Re: A & J Cartage Site Plan Review letter dated January 19, 2022

Re: A & J Cartage Site Plan Review letter by SAFEbuilt dated January 20, 2022

Re: A & J Cartage Site Plan Review No. 1 dated January 19, 2022

SITE PLAN FOR A & J CARTAGE

SHEET TITLE: **FLOOR PLAN**

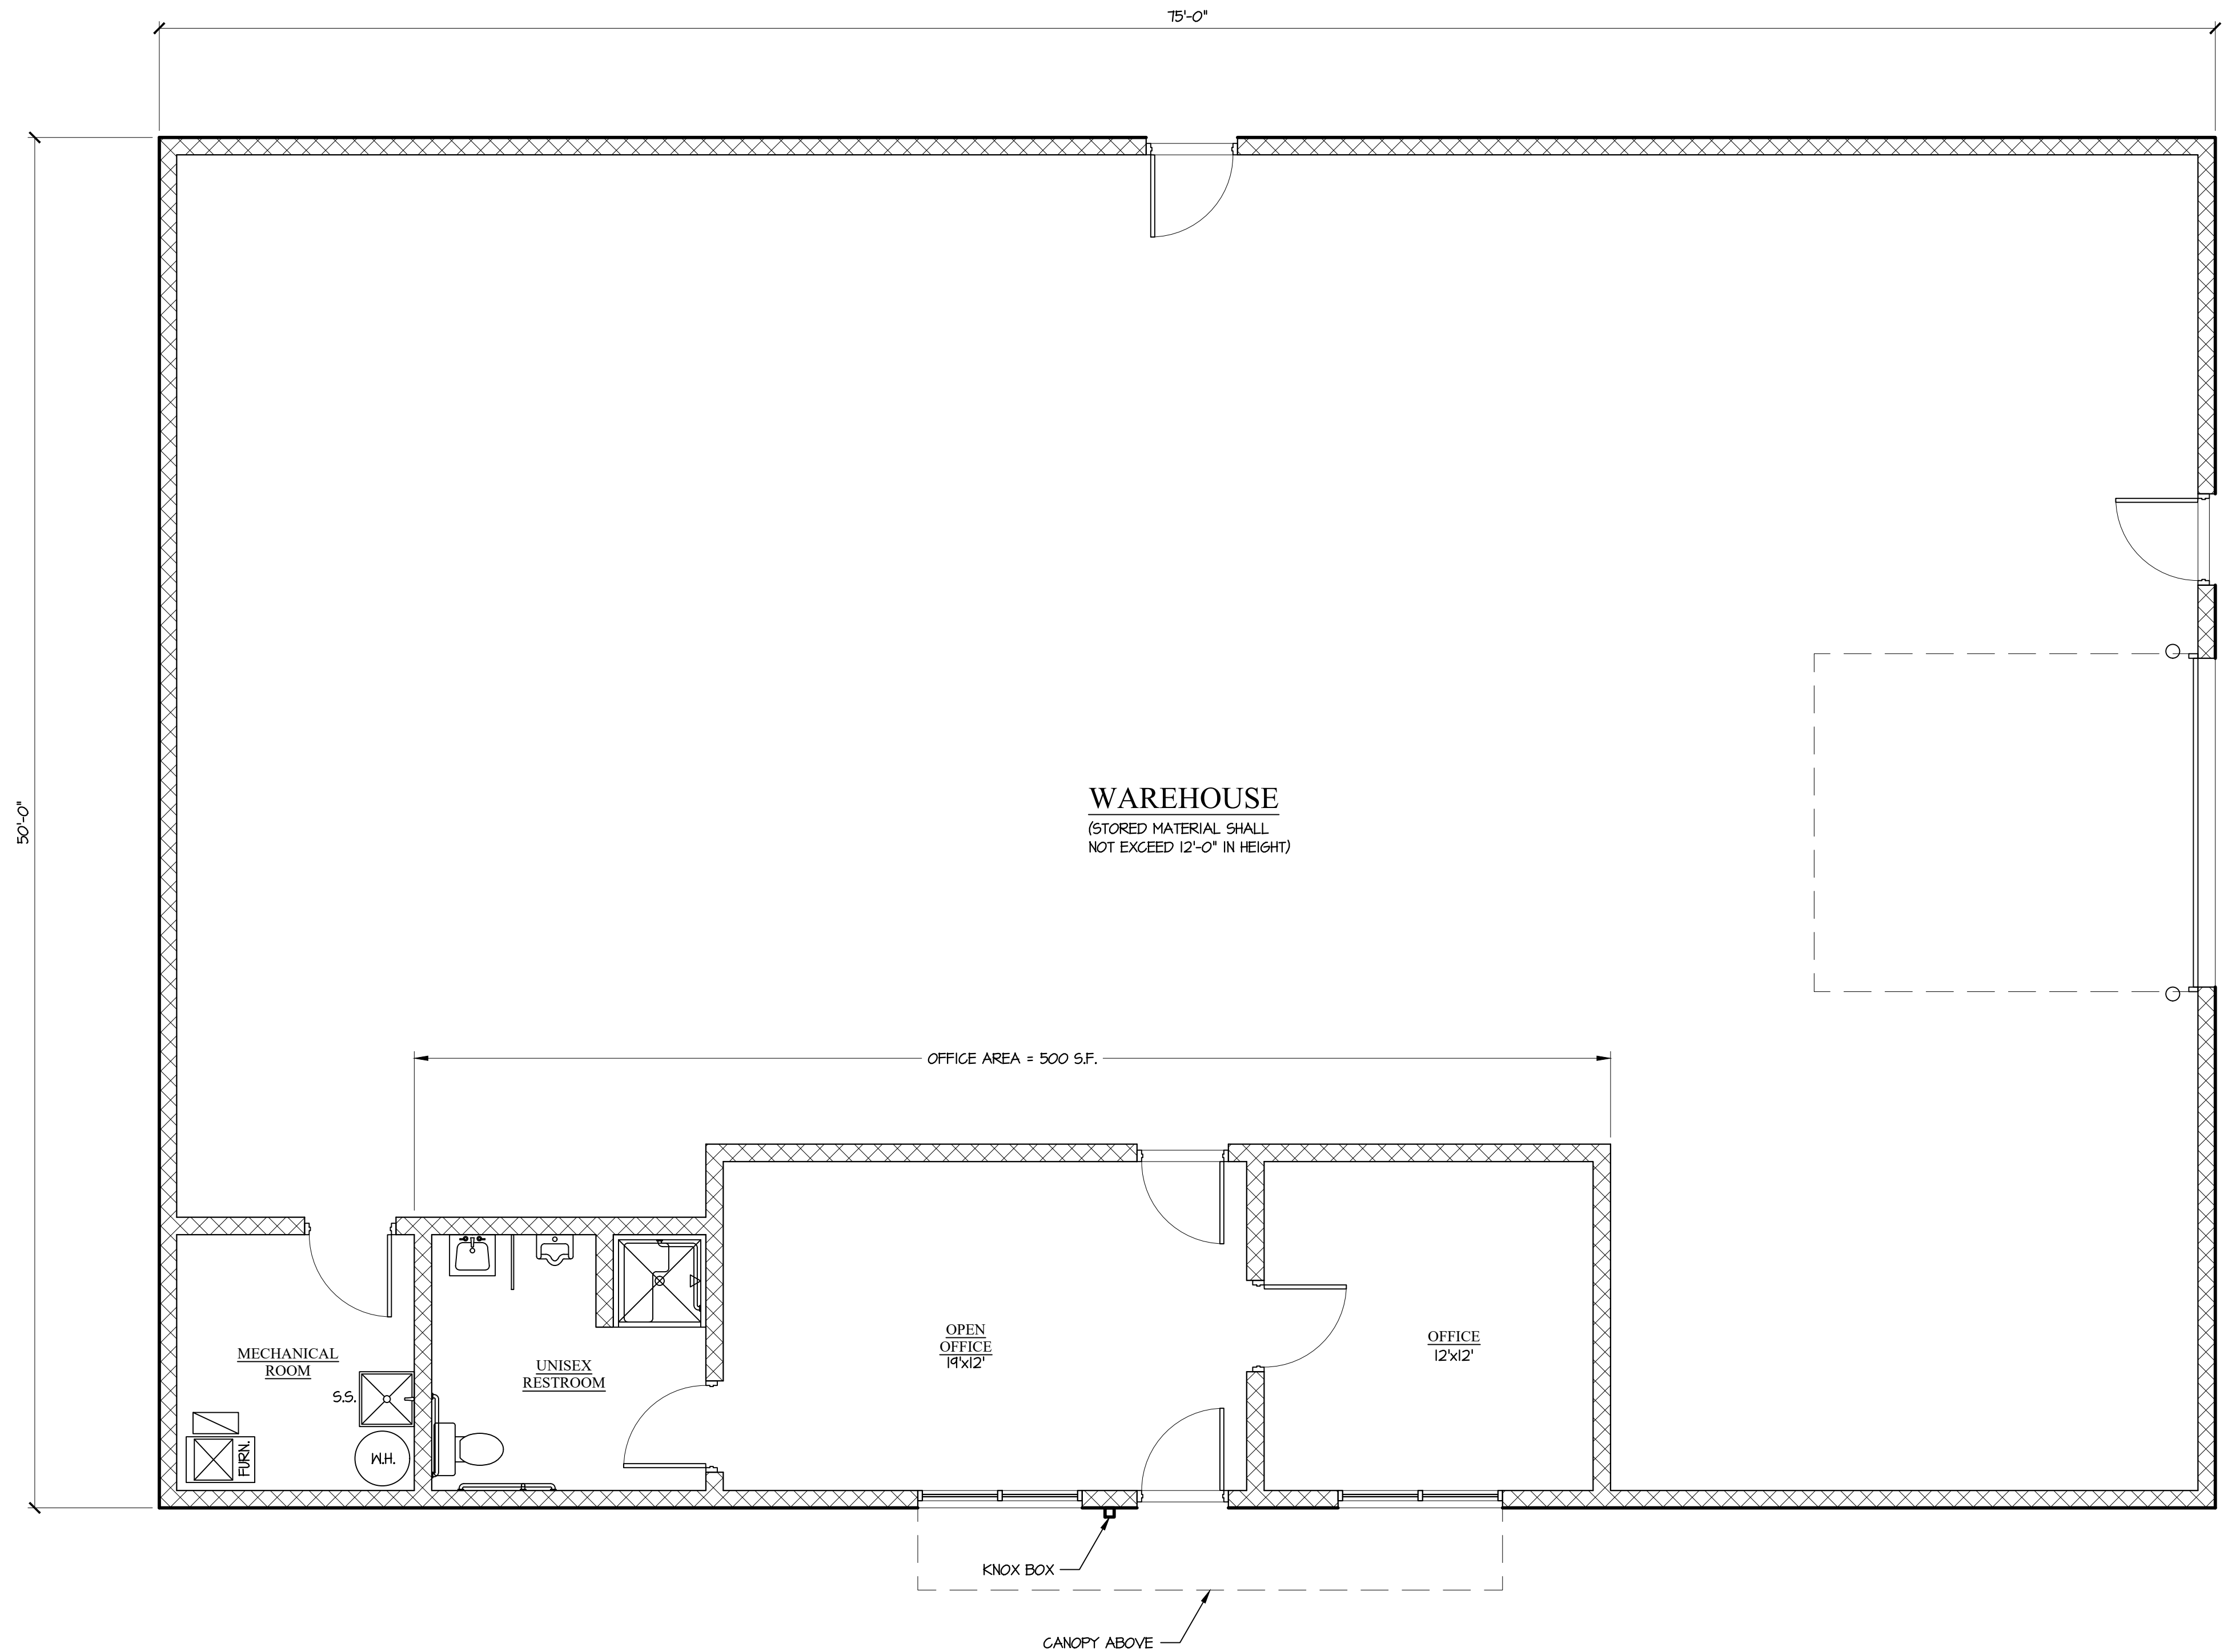
1. More details regarding building materials are indicated on the Architectural drawings in this resubmittal. See drawings by Pucci & Volmar at the end of the drawing set. In addition, samples of proposed materials will be presented at the Planning Commission meeting.
